<h1>Technical Bulletin</h1>	Model 928 All 911 C2/C4/T	Group 7
	Part Identifier 7201	Number 9301

Seat Rail Adjustment

Models Affected: *928 All model years*
 911 Carrera 2/4
 911 Turbo 1991—

Figure 1

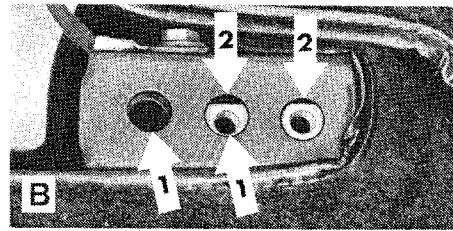
Concern: The seat rails for the above mentioned vehicles can be repositioned to allow for more leg room. The distance the seat is moved compared to the factory setting is 22.5mm for 911 Carrera 2/4/Turbo and 25mm for 928 models.

- Relocation Procedure:**
1. Move the seat to its rear most position and remove the two front allen head bolts which secure the seat rails.
 2. Move the seat to its forward most position and remove the four rear allen head bolts which secure the seat rails.
 3. On vehicles with electric seats, disconnect the wiring harness to the seat.
 4. Lift and remove the seat from the vehicle on 911 Carrera 2/4/Turbo models.
 5. **911 C2/C4/Turbo** - On the inside/rear securing point, place a 3mm thick washer, Part Number 999 025 125 09, on top of the rear thread bore opening (Figure A). It may be necessary to cut the carpet to access this area.
 6. **911 C2/C4/Turbo** - On the outside/rear securing point, slide the threaded plate to the rear bore opening (Figure B). Reinstall and secure the seat.
 7. **928 Models** - Slide the seat to the rear mounting points and secure the seat (Figure C).

Arrow 1: Production securing points
Arrow 2: Modified securing points
